From: Mark Leyse <markleyse@gmail.com>
Sent: Sunday, November 22, 2015 8:10 AM
To: Mohseni, Aby
Cc: Gilles, Nanette; Moore, Johari; Patrick.Castlernan@nrc.gov; Frazier, Alan; Cabbage, Amy; Bloomer, Tamara; Krsek, Robert; bobleuse@aol.com; shadis@prexar.com; Burnell, Scott; Bladey, Cindy; DeJesus, Anthony; Inverso, Tara; dlochbaum@ucsusa.org; elyman@ucsusa.org; mmckinzie@nrdc.org; tcochran@nrdc.org; gfettus@nrdc.org; balemayehu@nrdc.org; DBrancato@riverkeeper.org; PGallay@riverkeeper.org; Dean, Bill; Johnson, Michael; jim.riccio@greenpeace.org; Doyle, Daniel; Shane, Raeann; Weber, Michael; Paul Gunter; RulemakingComments Resource; PDR Resource; Diane Curran; Richard Webster; Clay Turnbull; CHAIRMAN Resource; michal_freedhoff@markey.senate.gov
Subject: [External_Sender] Fwd: Status of PRM-50-93/95

Subject: Re: Status of PRM-50-93/95

- 1) F. F. Cadek, D. P. Dominicis, R. H. Leyse, Westinghouse, "PWR FLECHT (Full Length Emergency Cooling Heat Transfer) Final Report," WCAP-7665, April 1971, (ADAMS Accession No. ML070780083).
- 2) NRC, "Draft Interim Review of PRM-50-93/95 Issues Related to Conservatism of 2200 degrees F, Metal-Water Reaction Rate Correlations, and 'The Impression Left

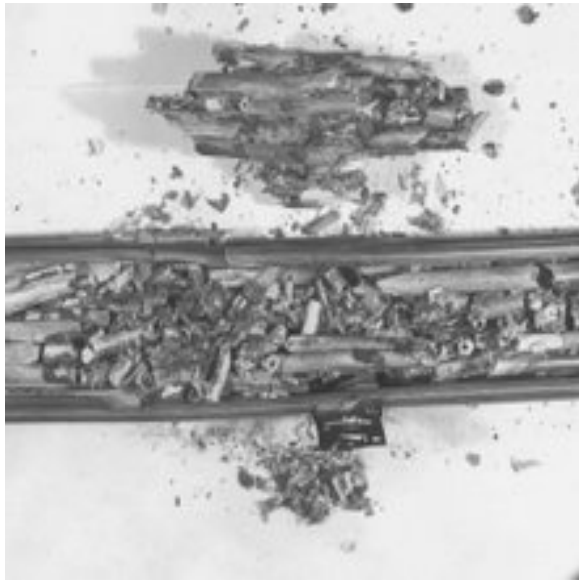
An adequate TRACE simulation of Run 9573 would have predicted cladding temperatures for the test bundle's 7 foot elevation at either 18 seconds or 18.2 seconds. Or an adequate TRACE (or another code or a modified version of TRACE) simulation of Run 9573 would have predicted steam temperatures around the test bundle's 7 foot elevation at either 16 seconds, 18 seconds, or 18.2 seconds.

Such a TRACE simulation of Run 9573 could have been compared to the Westinghouse data indicating that thermal runaway occurred around the test bundle's 7 foot elevation.

The severe-damage zone where thermal runaway occurred--within approximately ± 8 inches at the 7 foot elevation.
